TOWN OF CORTLANDT PLANNING BOARD

**MEETING AGENDA..... PLANNING BOARD
TOWN OF CORTLANDT
6:30 TUESDAY EVENING*
MARCH 3, 2026**

PB 2025-7 a. Public Hearing: Application of the Yeshiva Ohr Hameir for Site Plan approval, an amended Special Permit for a University, College or Seminary and a Wetland Permit for a proposed 51,730 sq. ft. dormitory building, the repurposing of other buildings on site, and site improvements including stormwater, landscaping and building façade renovations located at the existing Yeshiva Ohr Hameir campus at 141 Furnace Woods Rd. Drawings latest revised February 18, 2026. (see prior PB 7-09)

LaBella has performed a review of the plans prepared by Ciarcia Engineering, P.C. in support of the “Amended Site Plan associated with the construction of the three-story dormitory building, extension of sanctuary building, conversion of existing classrooms to staff housing, storage building, cafeteria and kitchen renovations, chalet renovation, façade improvements, and associated utility improvements. submitted on February 9, 2026.

PROPOSED ON-SITE WATERMAIN

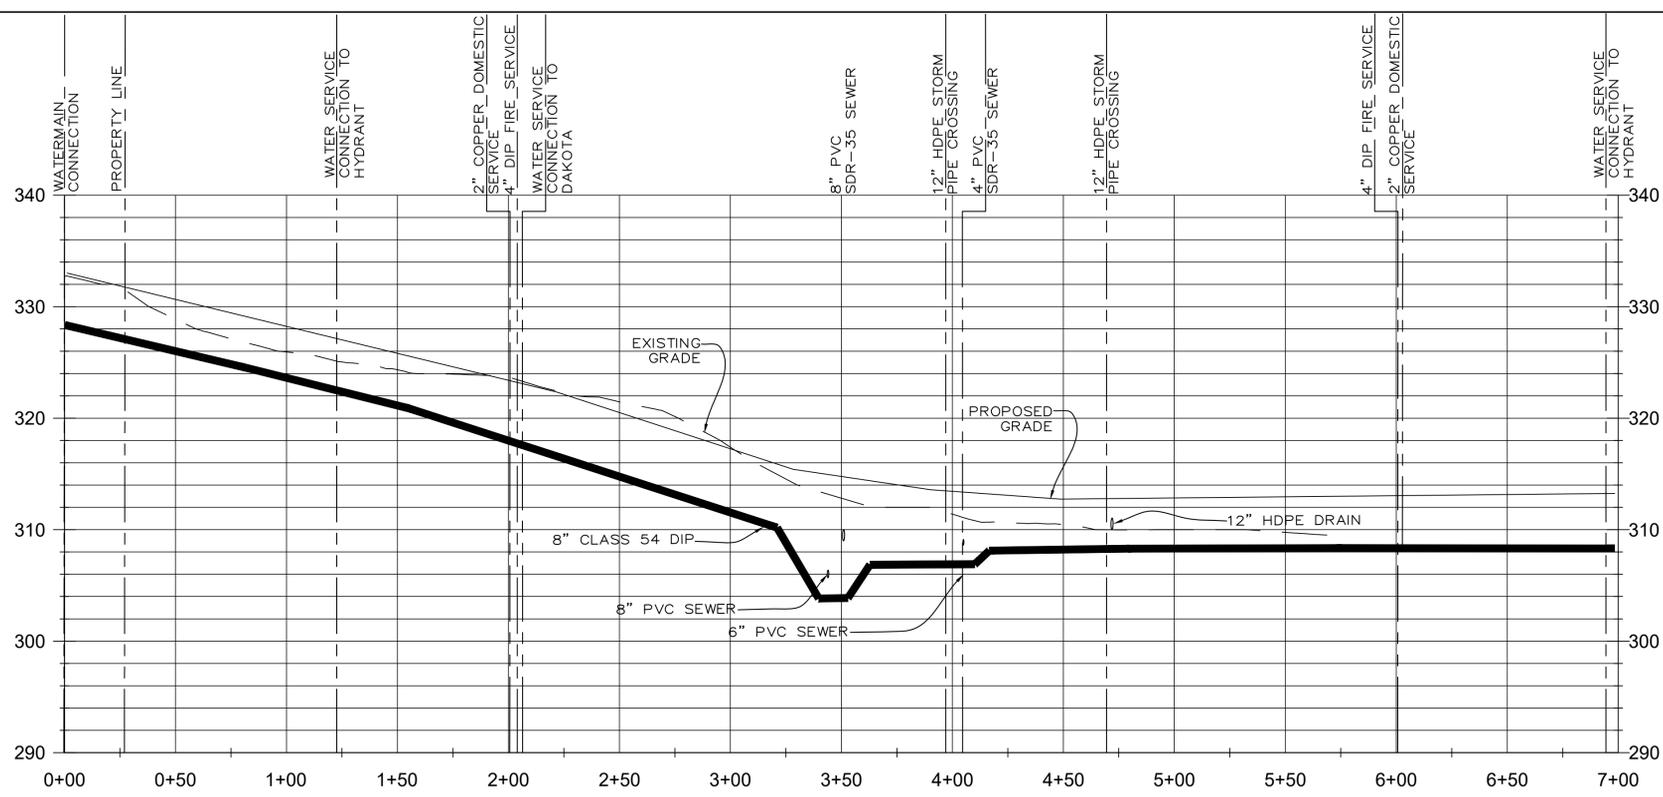
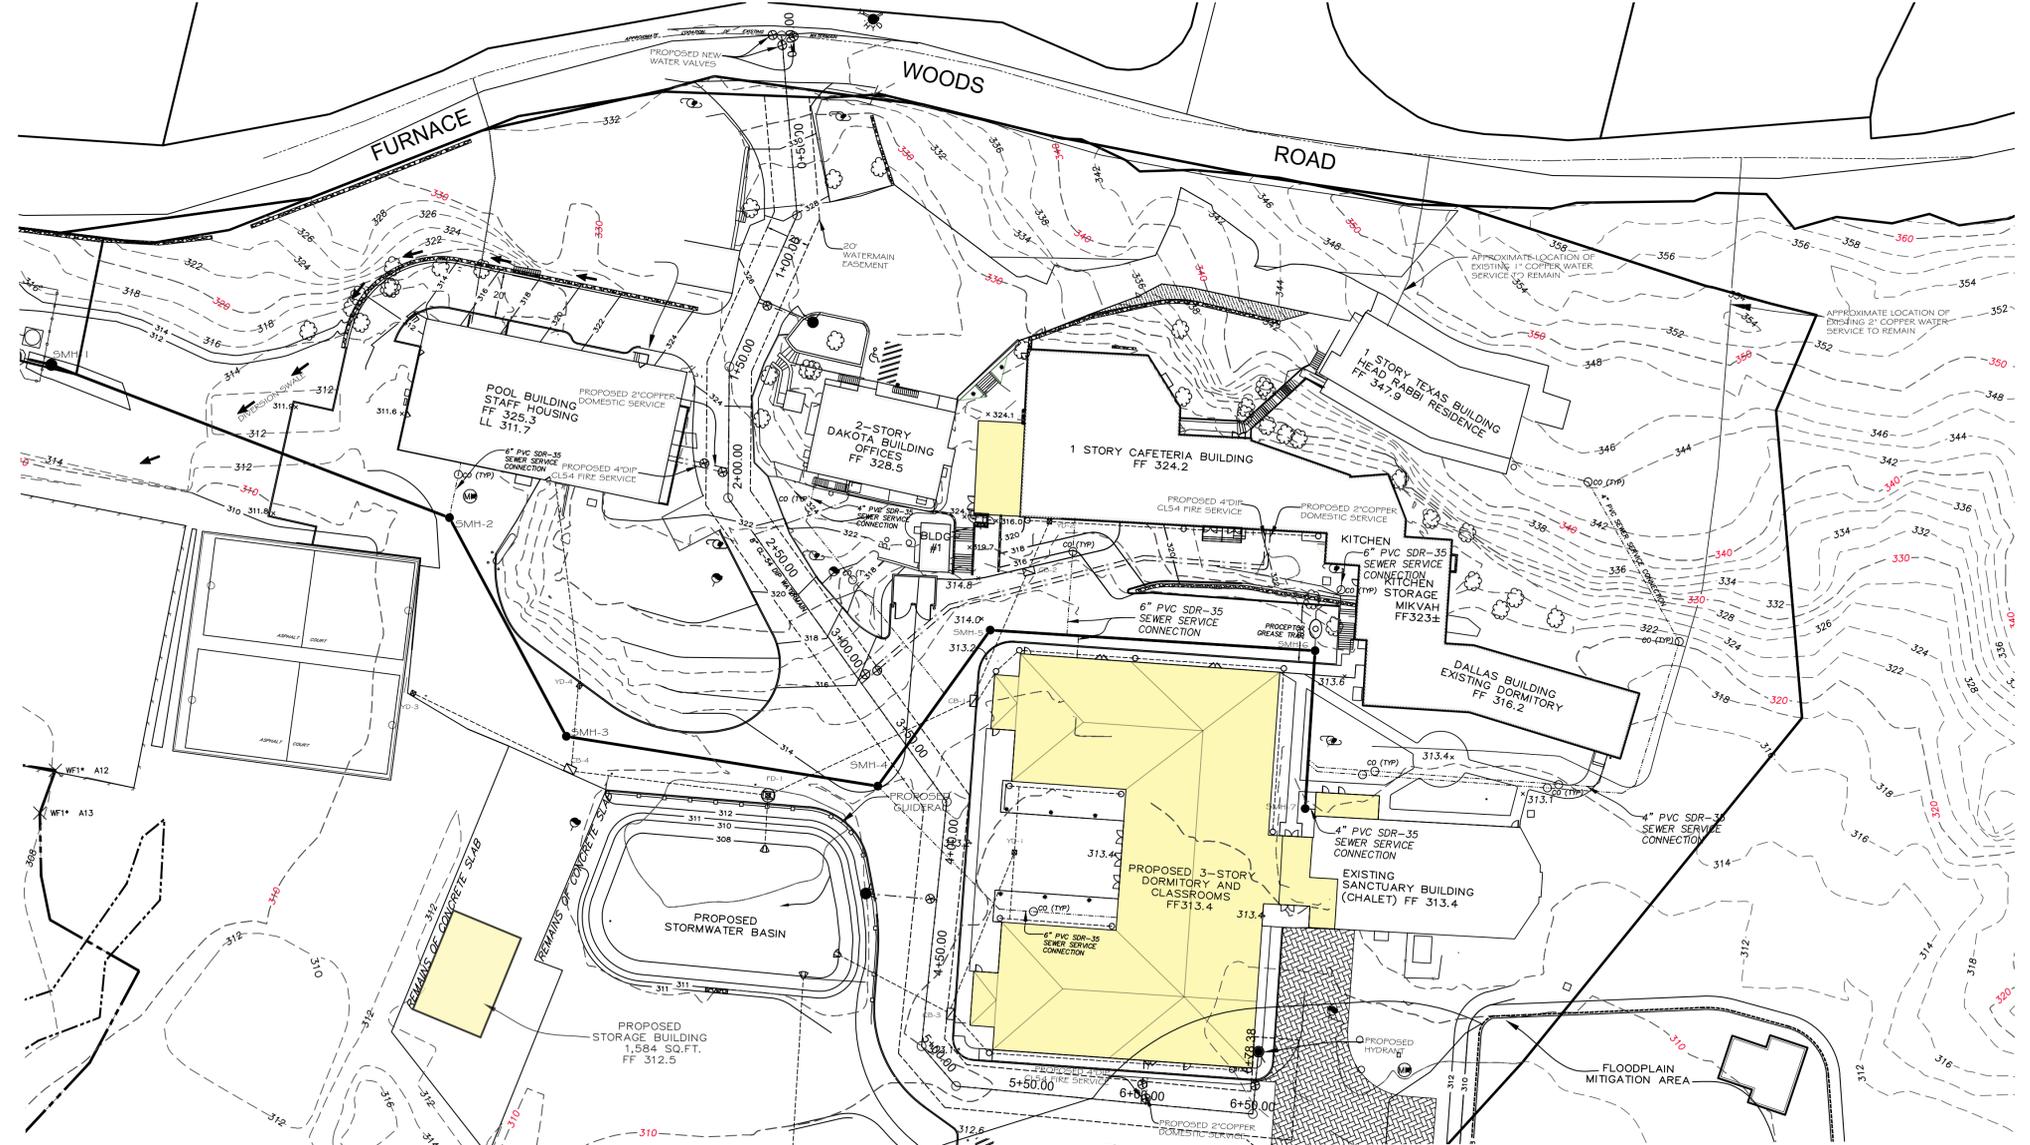
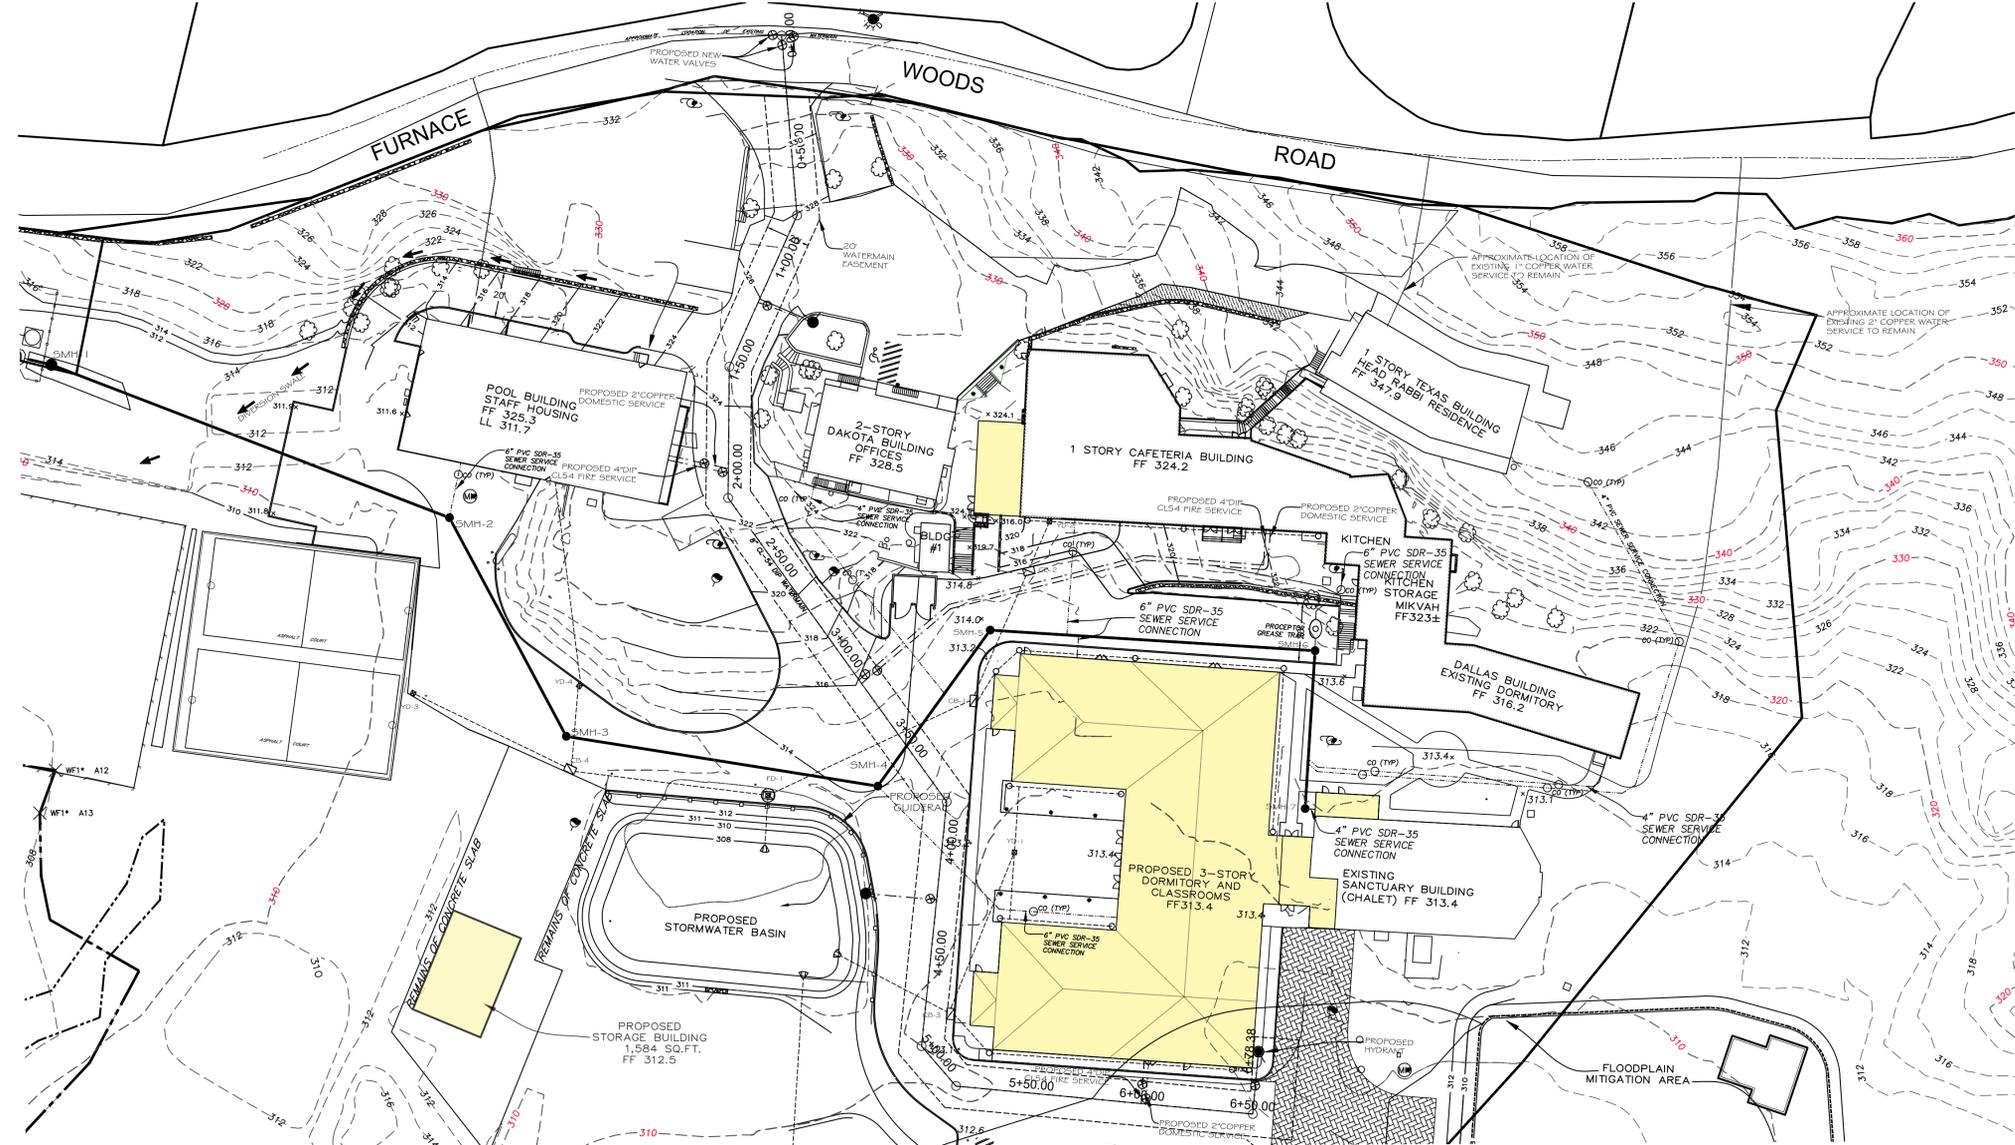
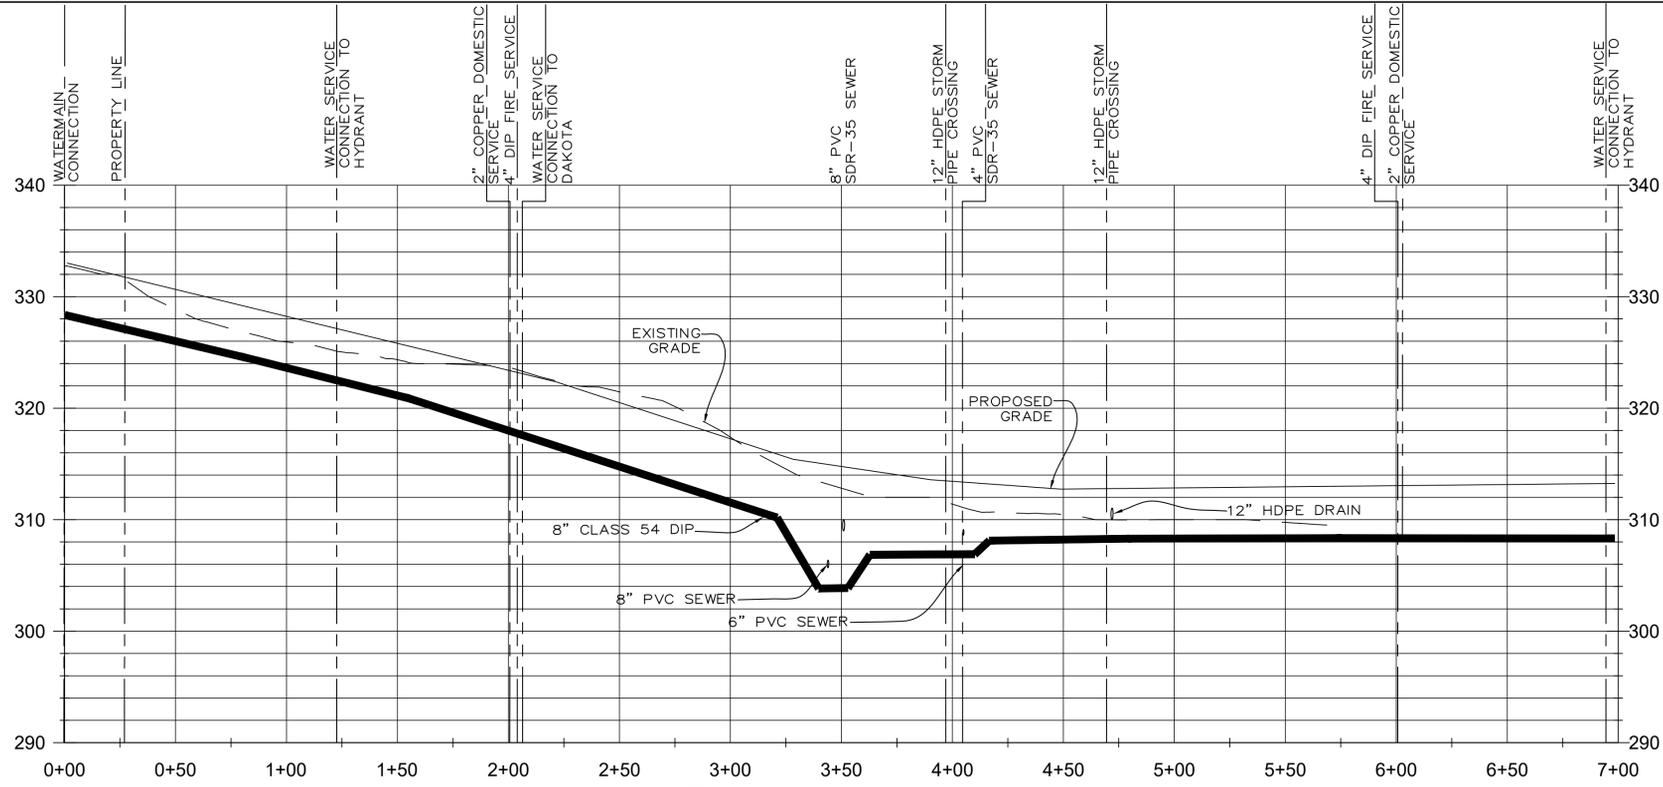
- 33. Sheet 7 of 15 – Stationing does not align with tick marks.
- 34. Sheet 7 of 15 – a straight section of watermain 20-ft in length shall be centered on the 8-inch sanitary crossing, with a minimum separation of 1.5-ft at approximately Station 3+50.

- 35. Sheet 7 of 15 – A few pipe symbols do not align with stationing leaders.
- 36. Sheet 7 of 15 - Hydrant at southwest corner of the building should be located on the southern side of the pavers.

- 37. Sheet 7 of 15 – Depict utility crossings, hydrants, and service connection including their stations and inverts on watermain profile. **PREVIOUS COMMENT PARTAILLY ADDRESSED**

- 38. Sheet 7 of 15 – Provide minimum cover depth on watermain profile. **PREVIOUS COMMENT NOT ADDRESSED**
- 39. Sheet 7 of 15 – A 2-inch domestic feed to the dormitory is proposed. As the building will be designed to accommodate 320 students, confirm the adequacy of the domestic service. Also, confirm the adequacy if 4-inch service with Project Architect/MEP to accommodate fire service. **PREVIOUS COMMENT NOT ADDRESSED**

MOHEGAN FIRE DEPARTMENT
LADDER TRUCK TEMPLATE

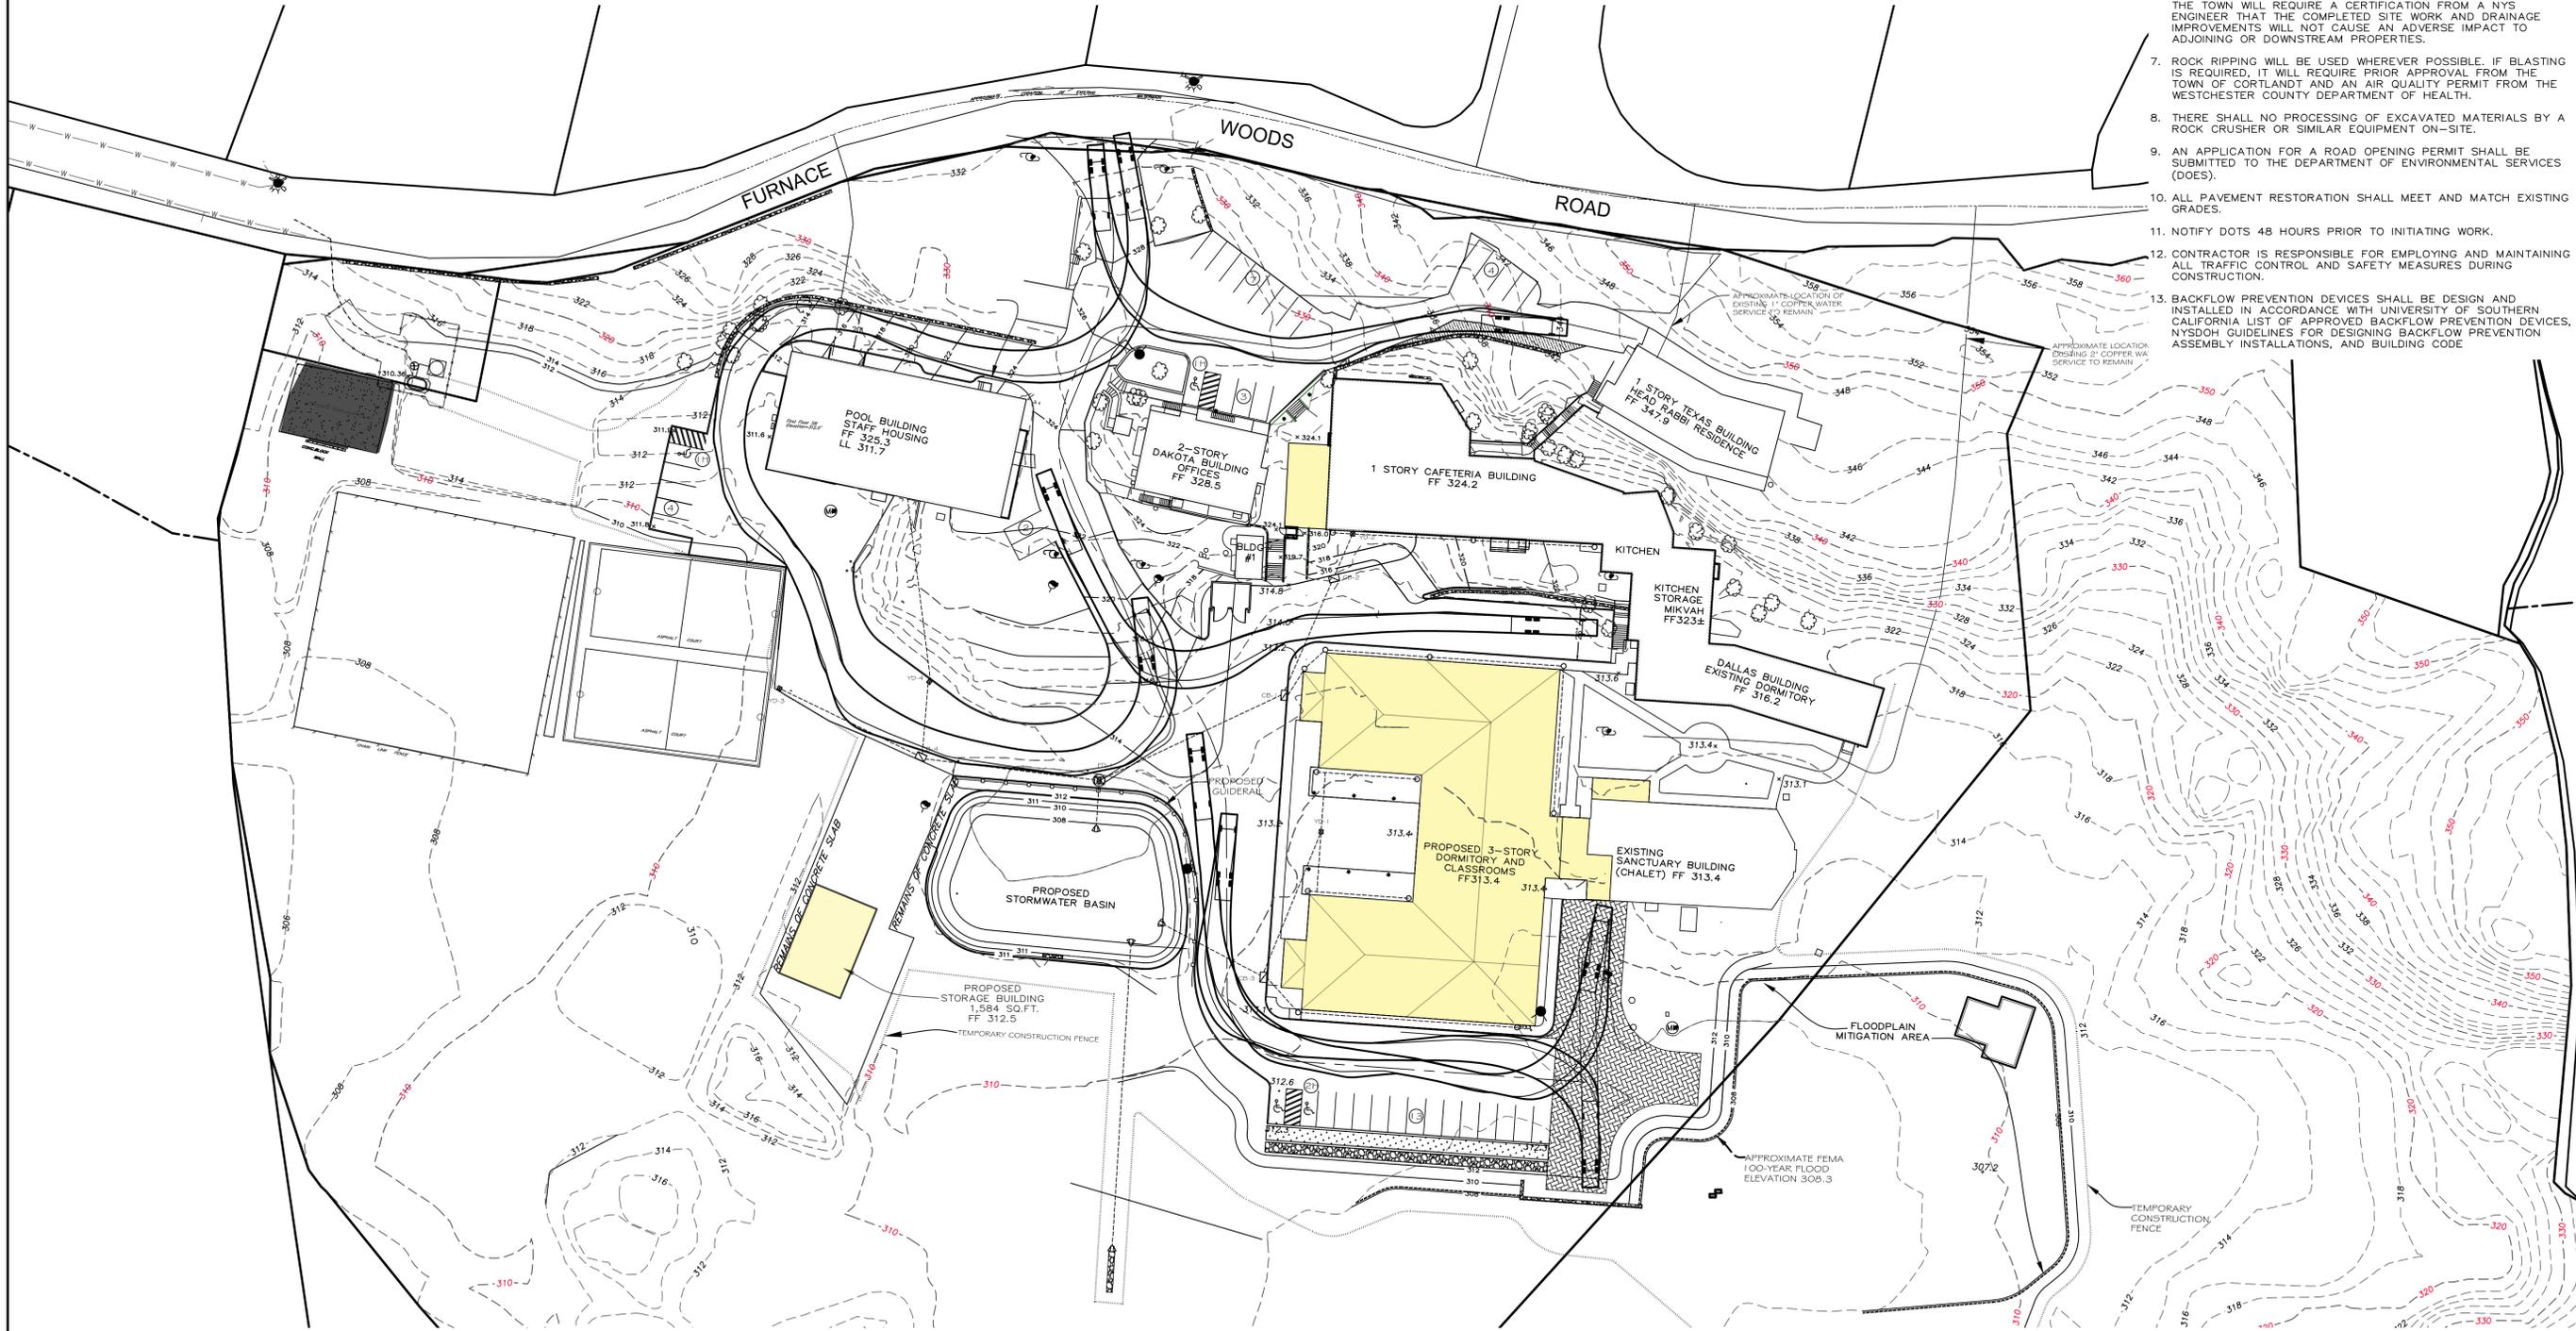
- 41. Sheet 9 of 15 – Provide fire truck detail and turning template on plan. PREVIOUS COMMENT PARTIALLY ADDRESSED**
- 42. Sheet 9 of 15 – The area apparatus turning movement is not contained within the roadway or encroached upon a retaining wall at a number of locations and should expand the roadway and remove obstructions to accommodate movements. For example, the fire truck path is shown outside the edge of pavement west of the Dakota building and in conflict with the retaining wall near the Texas Building. PREVIOUS COMMENT PARTIALLY ADDRESSED**

- 43. Sheet 9 of 15 – Provide documentation that grass pavers can support the weight of the aerial apparatus. Also include signs in the area indicating no stockpiling of snow or parking in the grass paver area. **NOT ADDRESSED**

44. Sheet 9 of 15 - The maximum allowable slope along the path of a fire access shall be 10%. Re-grade to between 314 and 316 to accommodate the required slopes. **PREVIOUS COMMENT PARTIALLY ADDRESSED**

Response 41: The drive through analysis based on the Mohegan Fire Department's ladder truck incorporates the turning template for that truck. The turning template is provided on the Fire Protection Plan, Fire Truck Turning Analysis sheet (Sheet 10 of 16)/
